Technical Service Bulletin

01 MIL on (DTC P0491 and P0492)

01 15 11 2039899/1 March 3, 2015.

Model(s)	Year	VIN Range	Vehicle-Specific Equipment
Q7	2011 - 2015	All	3.0T engine

Figure 1. All components highlighted in red must be replaced.

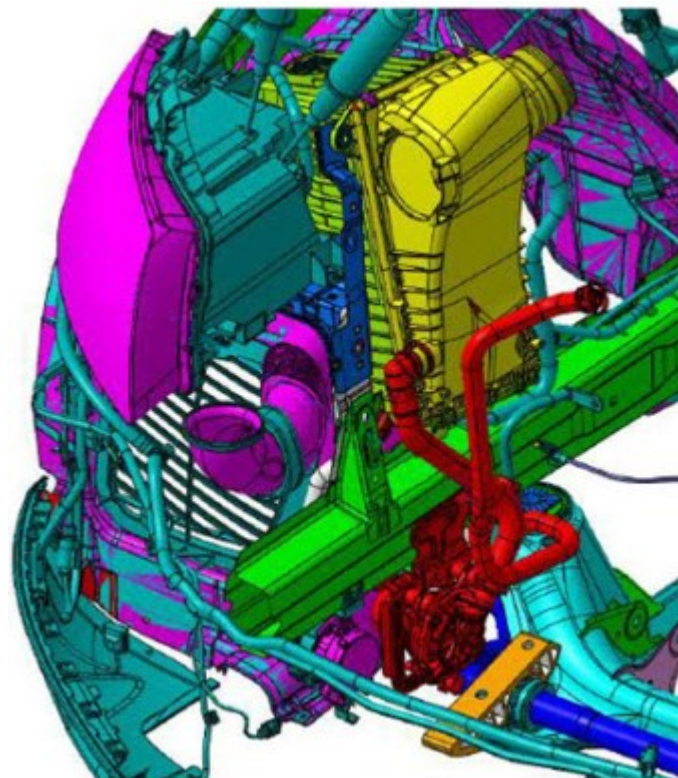
The pump has a different air hose connection and mounting points, so the intake and exhaust hose of the pump and the bracket must also be replaced (Figure 1, red).

Improved secondary air pump.
